Comment Report

37-8401

Water Right
37-8401
(IRRIGATION)

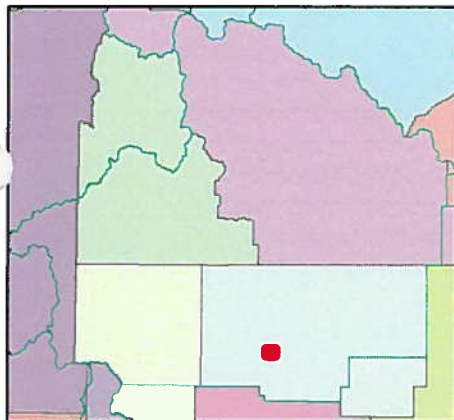
1. csaxton 12/19/2011 11:04:51 AM POD
Comment: Updated Shape
2. csaxton 12/19/2011 12:48:29 PM POU
Comment: Updated Shape
3. csaxton 12/19/2011 12:49:13 PM POU

Comment: Updated PLS
4. csaxton 12/19/2011 12:55:36 PM POU
Comment: Updated Shape
5. csaxton 12/19/2011 1:04:42 PM POU
Comment: Updated Shape
6. csaxton 12/19/2011 1:41:34 PM POU

Comment: Updated Shape
7. csaxton 12/19/2011 Diversion Rate Limit
Comment: No previous diversion rate limits for overlapping rights 37-59B, 37-423, 37-424, and 37-425. Added overlapping condition limiting overall diversion rate for 37-59B, 37-423, 37-424, 37-425, and 37-8401 to the sum of the diversion rates for 37-59B, 37-423, 37-424, and 37-425.

8. csaxton 12/19/2011 Diversion Volumes
Comment: No volumes decreed for 37-59B, 37-423, 37-424, and 37-425. No overall diversion volume limit added.
9. csaxton 12/19/2011 POU

Comment: All of the POU developed under this supplemental right directly overlaps 37-59B, 37-423, 37-424, and 37-425. Yet this right does not fully overlap all the acres authorized under 37-59B, 37-423, 37-424, and 37-425.
